STAFF REPORT COMMUNITY DEVELOPMENT DEPARTMENT

HEARING DATE: December 15, 2020

SUBJECT: H-2020-0005
Landing South – RZ, PP

LOCATION: 660 S. Linder Rd. (Parcel #S1213233965; NW ¼ of Section 13, T.3N., R.1W.)

D. Open Space Exhibit (dated: ~~May 28, 2020~~ October 5, 2020)

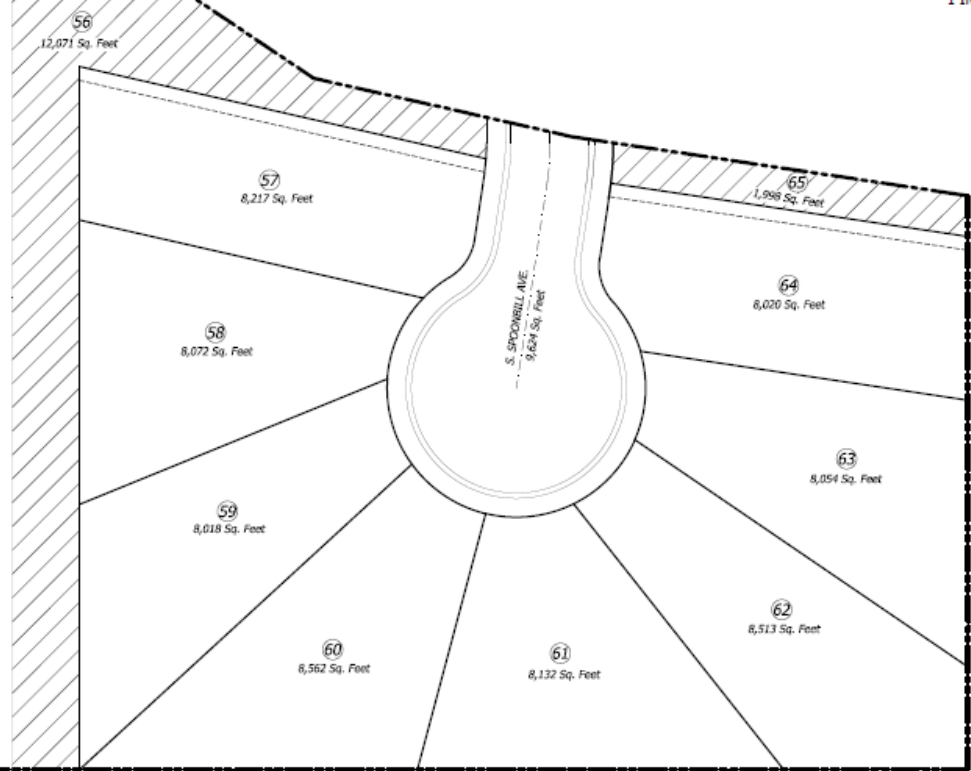
A minimum of 10% *qualified* open space meeting the standards listed in UDC 11-3G-3B is required for developments over 5 acres in size; because this property is only 2.27 acres, this standard does not apply. However, the Applicant did submit an open space exhibit that depicts ~~0.37~~ 0.32 of an acre of common open space including street buffer along Linder Rd. and area along the north boundary of the site where the Kennedy Lateral is located.
